# **Deadline 3 Submission on Behalf of the Neighbours and Users of Queen Elizabeth Park**

**Nick Jarman**

Interested Party reference no: **20022545**

Extract from General Arrangement Plans, sheet 106 with house numbers shown.

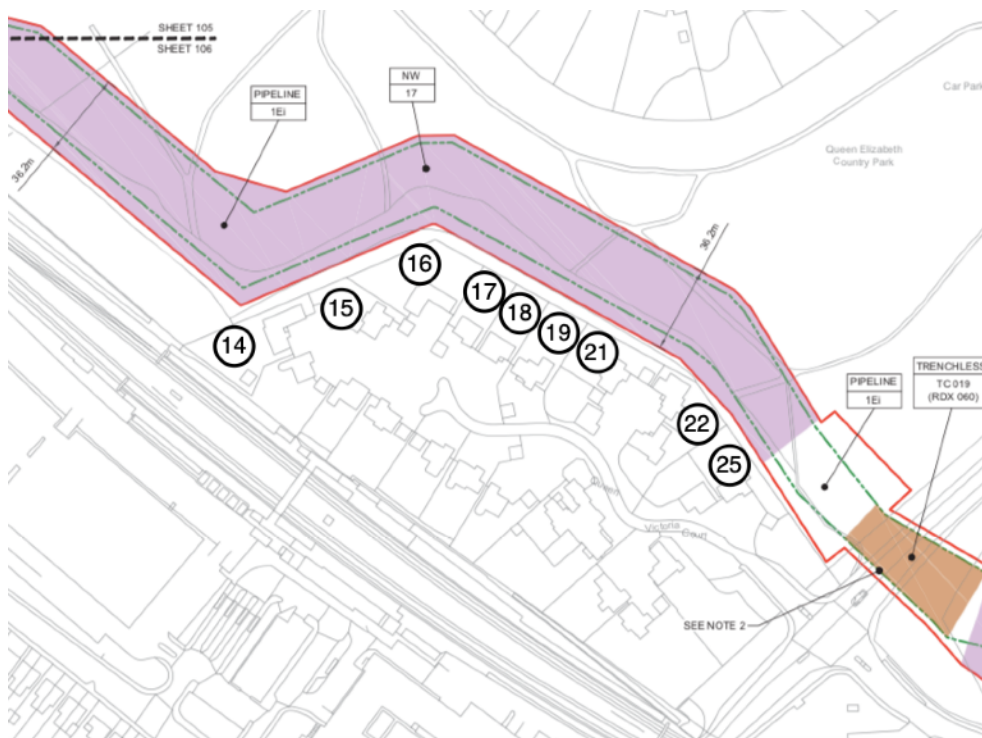
Table 1.8 lists the addresses with potential to be affected by construction noise. We do not think this list is complete because it omits some addresses which will be severely affected by the noise of installation works.

The Order Limits touch the boundary of 22 Queen Victoria Court so this property should be included in the affected list. However all other houses in Queen Victoria Court with gardens bordering the park have potential to be significantly adversely affected by construction noise. Of these, numbers 14, 21 and 25 are closest to the order limits.

Extract from General Arrangement Plans, sheet 34, with house numbers shown.

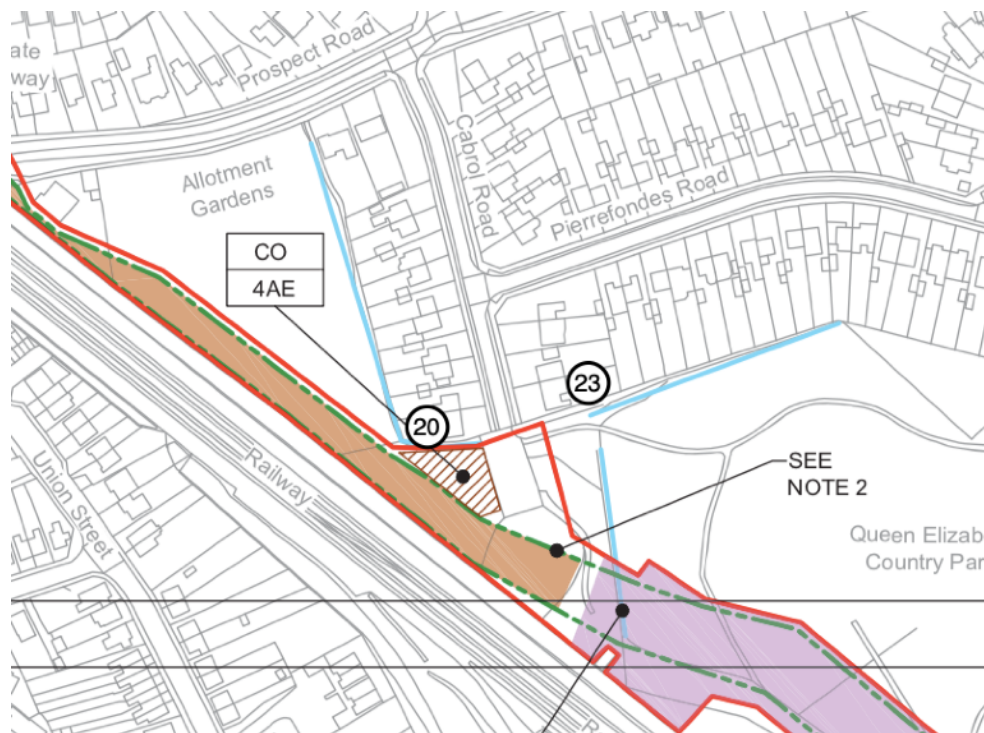
In Cabrol Road, the boundaries of numbers 20 and 23 border the Order Limits. The boundary of number 20 directly adjoins the proposed construction compound and so its residents are likely to experience significant disturbance from the activities within it.

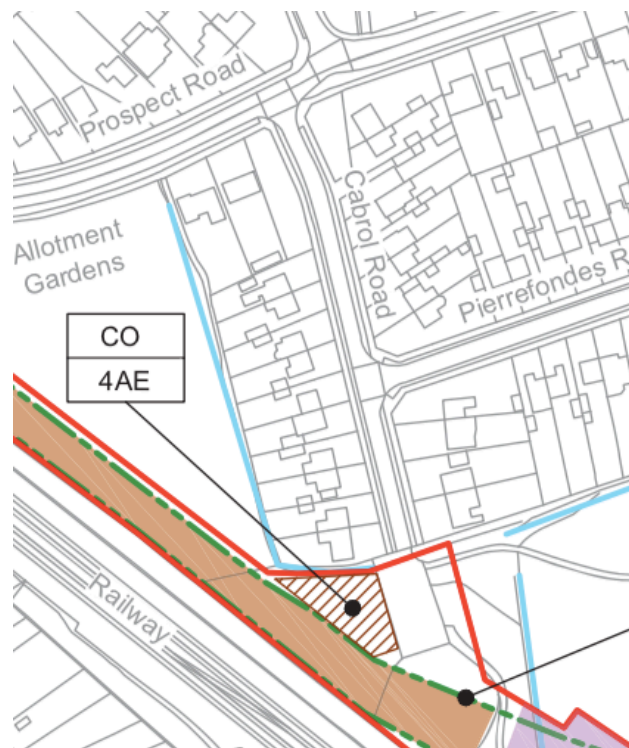
We believe that effective acoustic screening should be used throughout Queen Elizabeth Park and alongside the houses in Cabrol Road, due to the proximity of the order limits to adjacent houses. Both sides of the Order Limits should be screened because some houses in Pierrefondes Avenue could also be adversely affected.

If HDD were used within the park, the areas requiring noise screening would be much smaller.
